RE: Response to LUPC Comments of February 24, 2023

Jeremy Ouellette, Vice President Project Development  
WOLFDEN MT. CHASE LLC  
20 Main Street  
Patten, ME 04765

**Attachment A – Additional Mine Figures (#3)**

**Attachment B – Spray Irrigation/Snowmaking/Snow  
Storage**

FIGURE 2  
 POST-DEVELOPMENT  
 WETLAND CATCHMENTS  
 WOLFDEN RESOURCE CORPORATION  
 PICKETT MOUNTAIN MINE SITE  
 T6 R6, MAINE

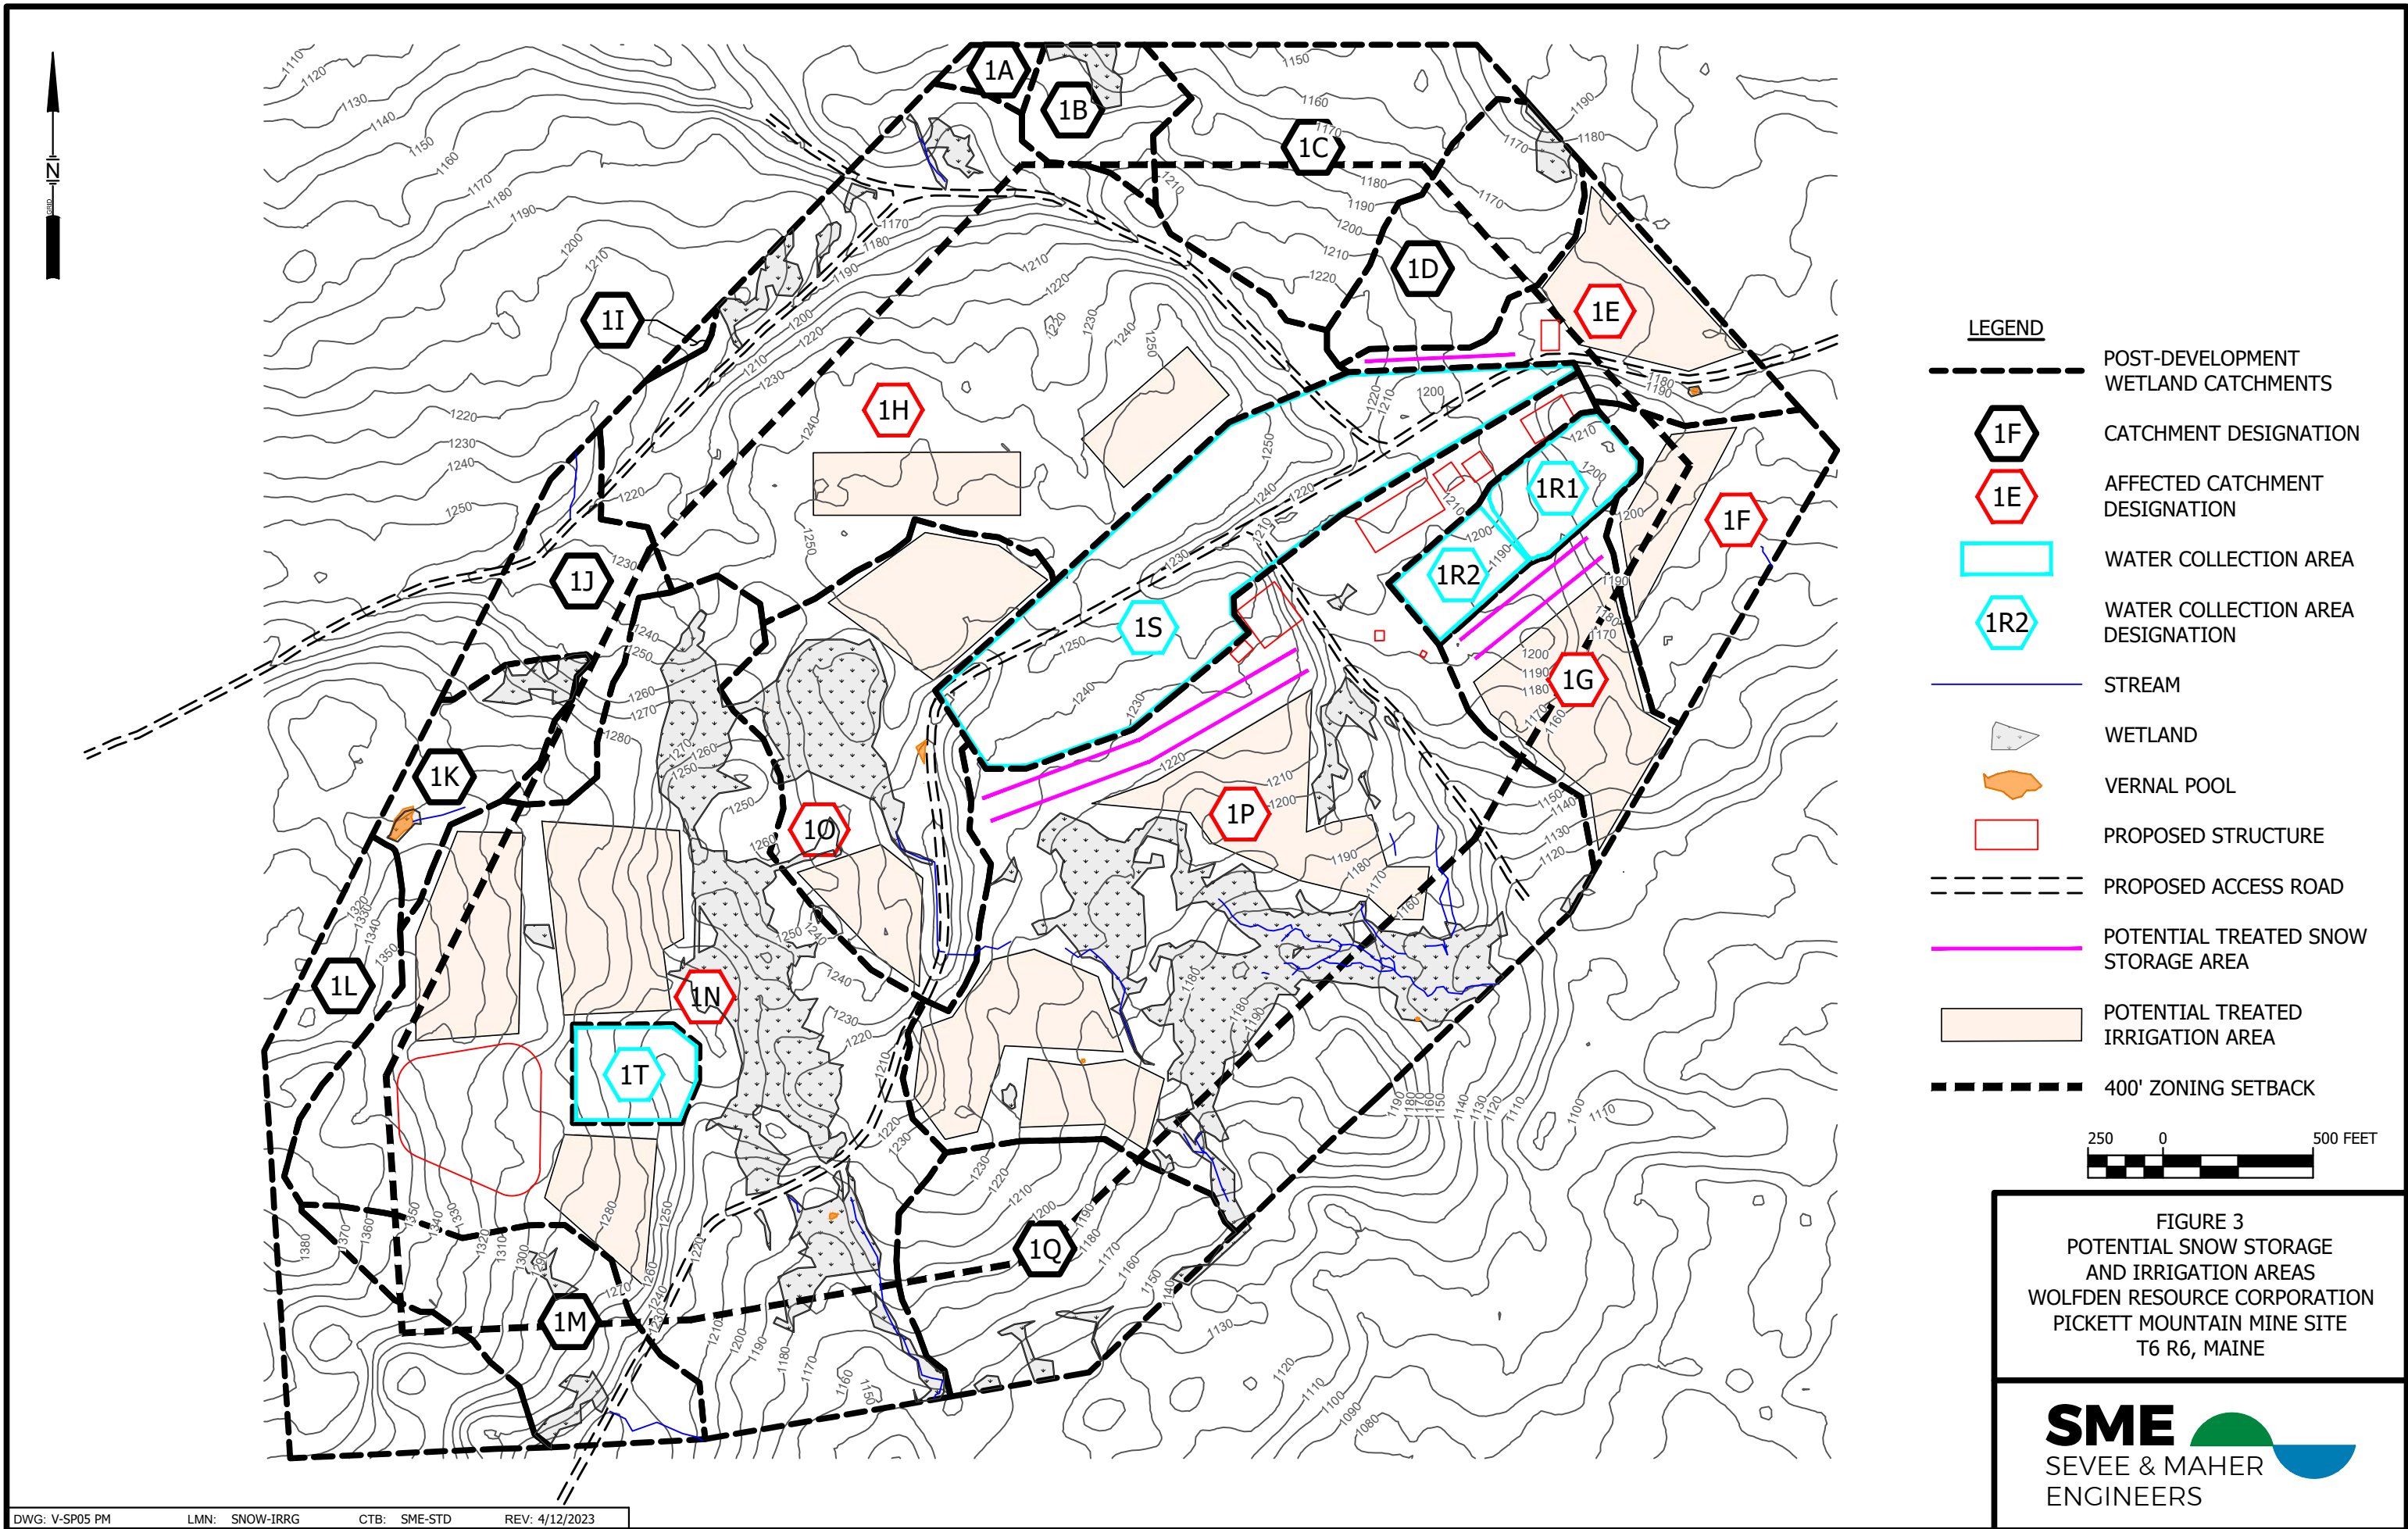
The application does not include a sufficient demonstration that the discharge of collected storm and mine waters would have no undue adverse impact on downgradient wetland and stream hydrology, especially considering the timing and quantity of water flows. If any wetland or flowing water will receive more or less water than pre-development, provide evidence to demonstrate that there will not be undue adverse impacts on those habitats or the species depending on those habitats. Consider if water would be diverted from one subcatchment area to another and that water from mine shaft dewatering may not have reached the streams pre-development and therefore will be a source of additional volume.

Three separate areas totaling approximately 31 acres will require collection of precipitation once the site is developed. These are shown as water collection areas on Figure 2 and include the following:

The proposed development will occur in seven of the initial 17 wetland catchments (1E, 1F, 1G, 1H, 1N, 1O, and 1P) and will alter natural precipitation recharge in those areas. To estimate the recharge to each wetland catchment during the developed condition, the affected wetland catchments delineated in Figure 1 were reduced to reflect the removal of the water collection areas from the wetland catchments (see Figure 2).
